**ADS-B 1090ES MOPS Maintenance**

**WG-3 Meeting #30**  
**SG-1 Meeting #7**  
**Joint Session**

**More Comments on the Draft of Appendix P**  
**In Response to Action Item 25-03**

<b>Summary</b>
This Working Paper addresses additional comments on the draft of Appendix P in Working Paper 1090-WP30-05.

**Traffic Density Measurements, 25 July 2007  
Centerpoint is JFK Airport**

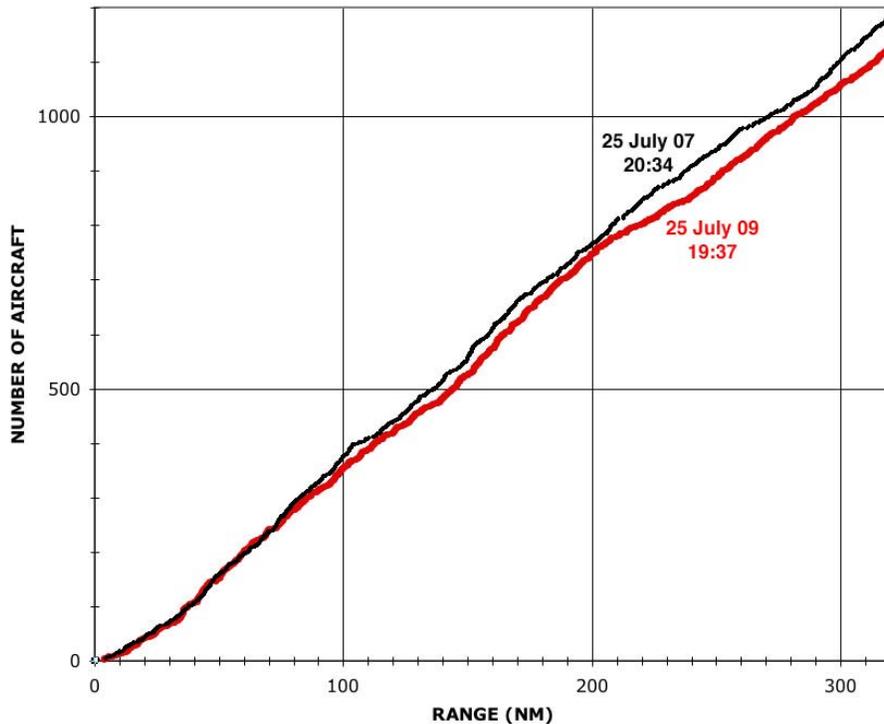
Paragraph 7 in P.5.1. In describing the measurements, I propose adding a figure to summarize the results. Here is a draft.
